**Staff Analysis of Proposed Amendment to the *Dane County*
Water Quality Plan, Revising the
Deerfield Urban Service Area Boundary and Environmental Corridors
in the Town of Deerfield**

1. Applicant: Village of Deerfield

**Map 1
Amendment
to the Deerfield
Urban Service Area,
Town of Deerfield**

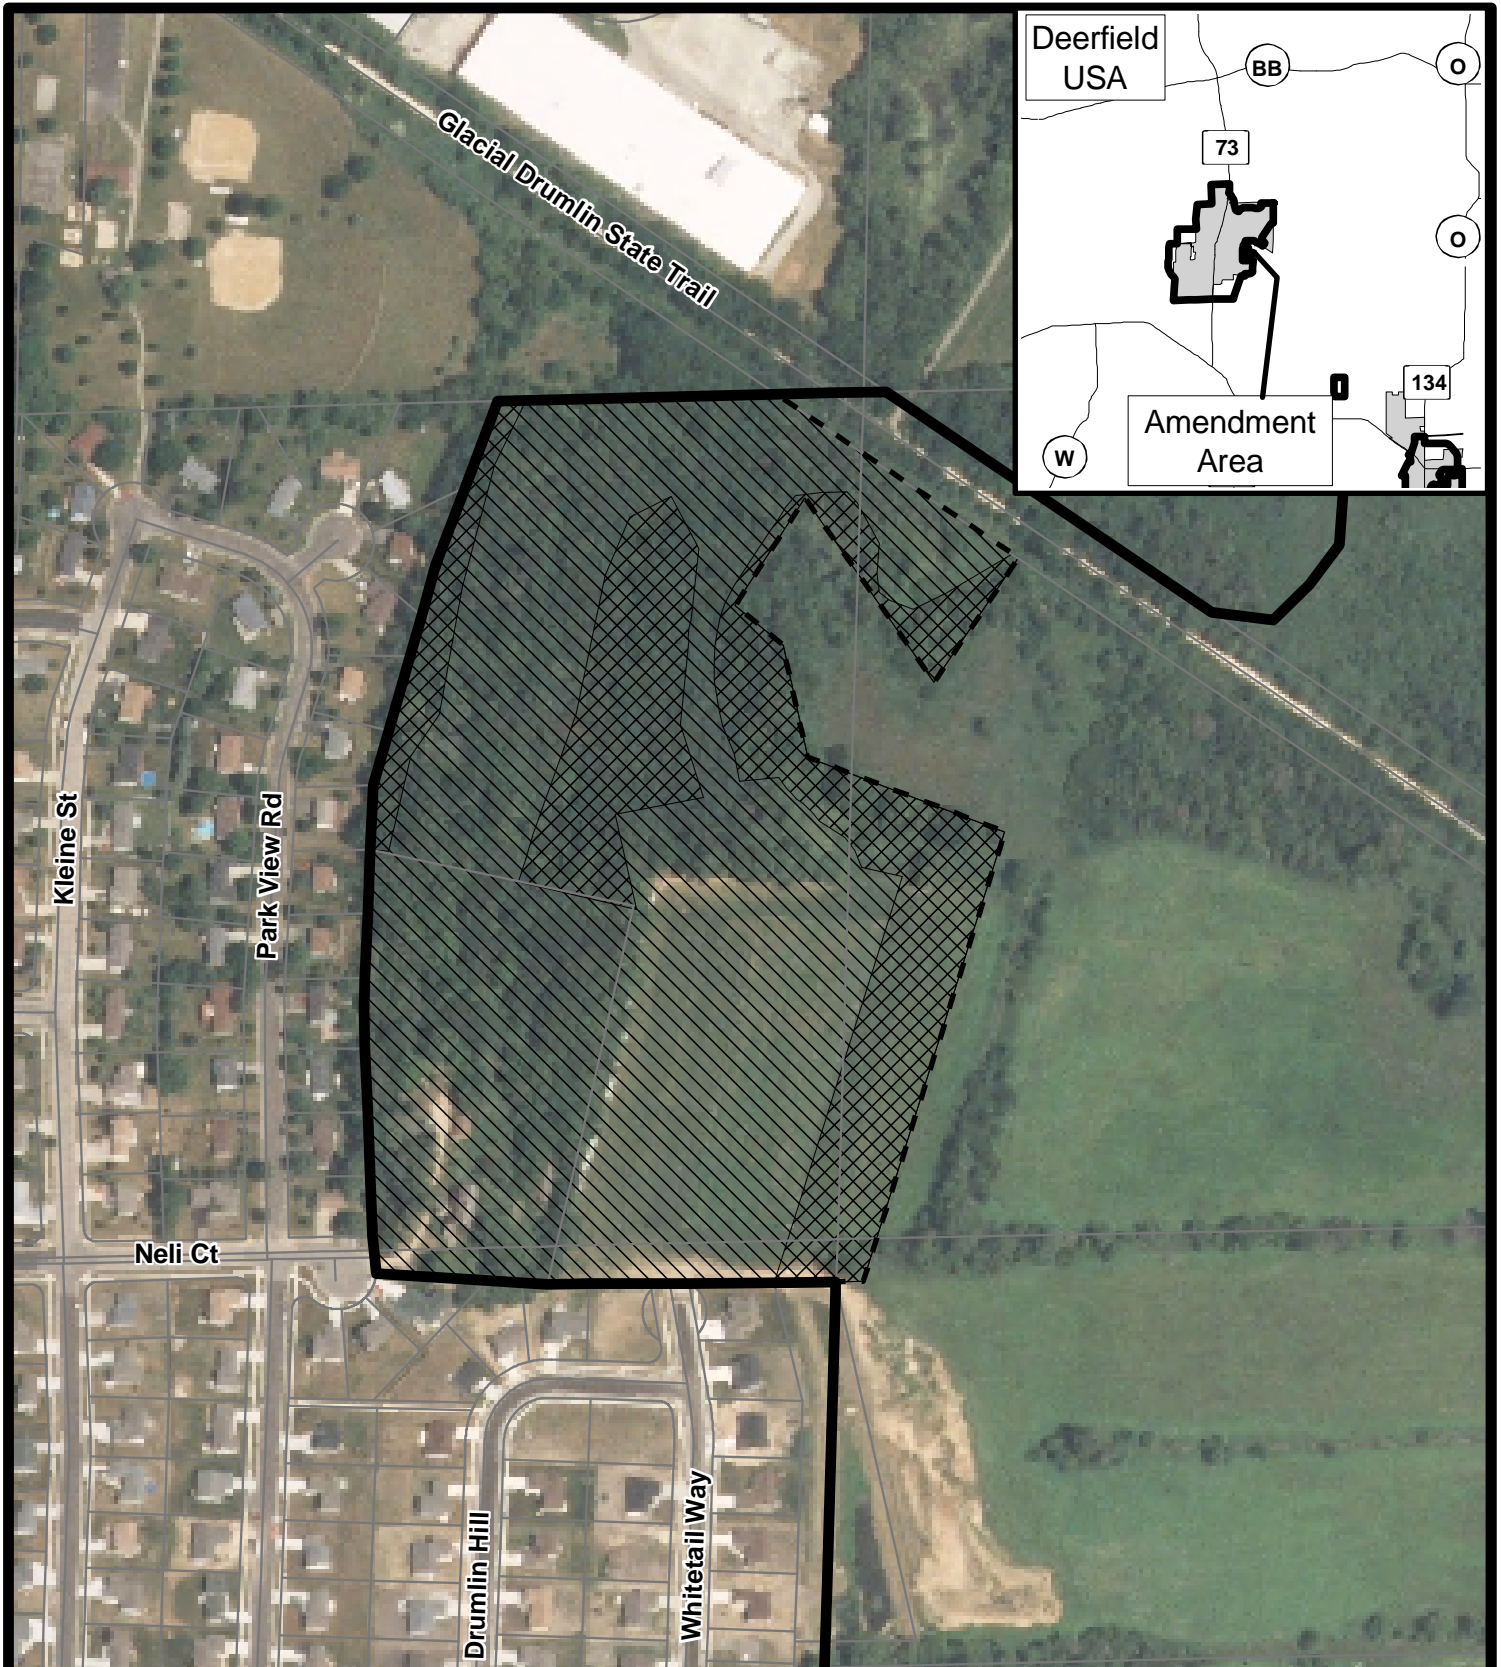
Environmental Corridors. The 7.1 acres designated as environmental corridors in the proposed amendment include wooded, steep slopes east and west of the ridge line, and a buffer area adjacent to nearby wetlands. The proposed buffer is less than 75 feet in four locations (see Map 1). One of these accommodates an access drive. Any attempt to move the drive away from the wetlands would require excavation into the side of the drumlin, potentially destabilizing the steep slopes. The environmental corridors policies allow streets and utilities to encroach into a buffer where practicable alternatives are not available.

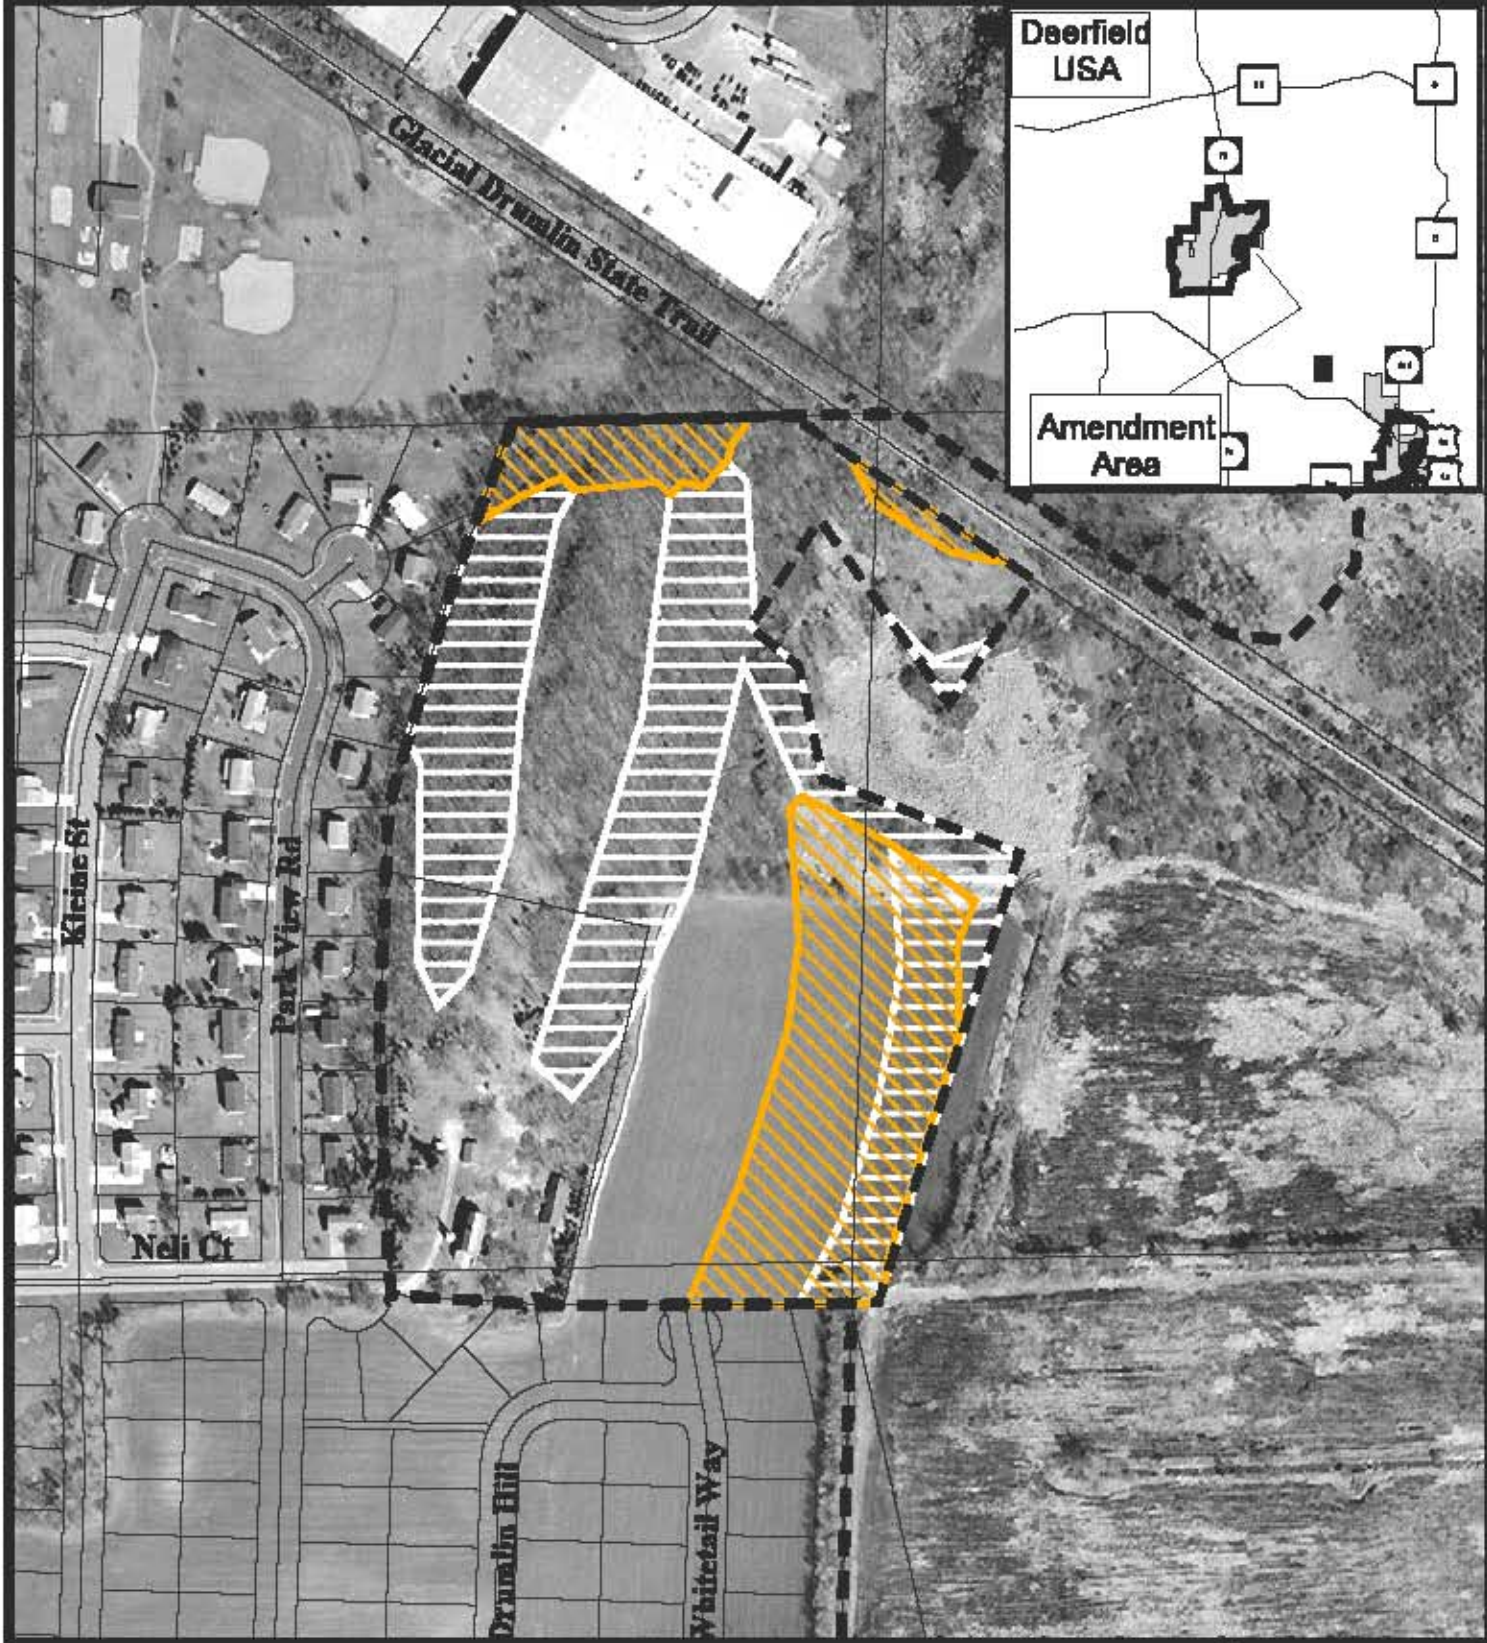
Urban Transportation System. According to the plat map provided with the submittal (see Map 3), the proposed amendment will extend Whitetail Way to the north, ending approximately half way through the amendment area. Neli Court will be extended east to connect with Whitetail Way. The northern half of the amendment area will be served by a 30 foot wide private access which will continue north from the end of Whitetail Way to provide emergency access via the Glacial Drumlin Bike Trail and also provide bicycle and pedestrian access to the trail. The private access will also loop around the wooded reserve area and turn south to provide access to the housing units located on the ridge. There are no other practicable access points to the ridgetop. Sidewalks will be provided along all new streets, as required by the Village subdivision ordinance.
